Below are comments for four different agenda items of the 1-30-2024 Transportation Commission meeting.

81632 Endorsing / prioritizing bike/ped connectivity as part of WisDOT's I-39/90/94 study

81653 Adopting the Lake Monona Waterfront Master Plan

81744 Vision Zero Annual Report

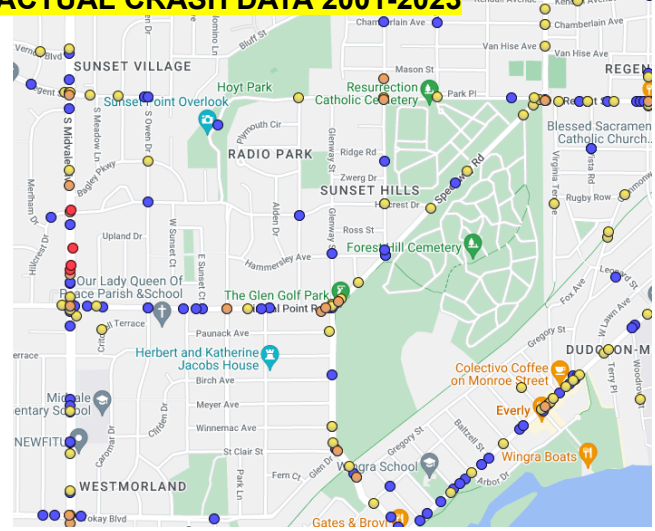
First, High Injury Network methodology used for Vision Zero doesn't seem close to actual injury crash data. E.g., Here is a spot comparison of near-west Madison.

Mineral Point Rd, Glenway, Monroe St, and Regent east of West High all have many real-world crashes with injuries, yet they are not flagged as part of the High Injury Network. The [2014 Near Westside Neighborhoods and University Avenue Corridor Transportation Study](#) (p. 45) indicated that the Glenway / Speedway intersection was the crashiest intersection on the near west side. Meanwhile, streets like Falles Ct are flagged for the High Injury Network even though it's never had a crash and probably doesn't see more than 10 cars an hour.
